Preservation Issues in the Patrick Tavern Porch Project

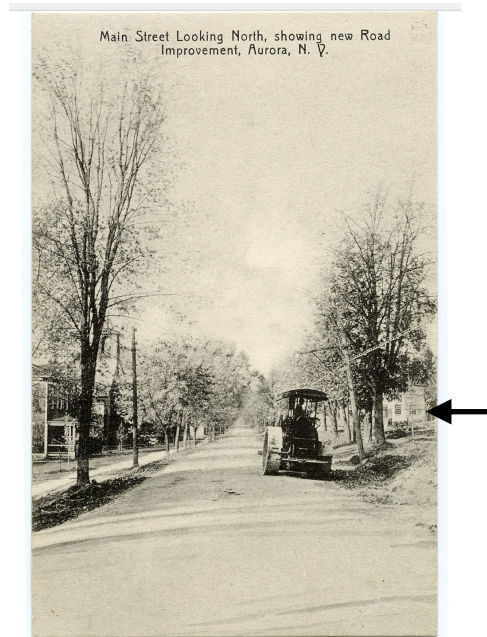
Railing: The low porch railing does not conform to modern safety standards. Preservation Brief #45, an interpretive guide for the Sec. Interior’s Standards, suggests a simple additional rail above the railing to give the required height.

Historic porches generally have handrails that measure 28 to 30 inches in height from the floor. Current code requirements for new construction generally mandate that railings be 36 to 42 inches in height (often 36 inches for single family dwellings, and 42 inches for multi-family dwellings and commercial buildings). Raising the historic railing by as much as 30% or more can have a major impact on not just the proportions of the balusters, but also on the overall appearance of a historic porch. Adding a simple rail above the historic railing and painting it to hide its presence as much as possible is generally the least intrusive solution when this safety requirement must be met. Similarly, an existing bottom rail is sometimes set too high off the deck to meet contemporary code requirements. The addition of a simple wood rail or even a narrow metal pipe below the bottom rail will usually suffice (Fig 19).

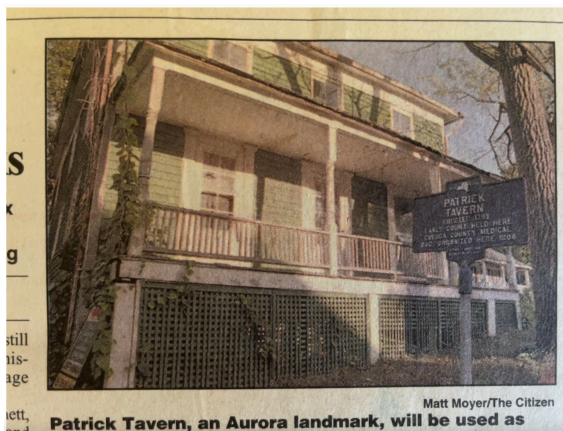
Paint: CPP asked how the current paint color was chosen. This color scheme, especially the light cream base color, is appropriate for the Settlement Era according to internet sources and historic paint collections. Although dark colors came into use in the approximate era of the porch, the above postcard, and one view of similar vintage from farther up Dublin Hill, show a light building. Dark paint (green?) first appears in a photo of St. Patrick's congregation in about 1915.
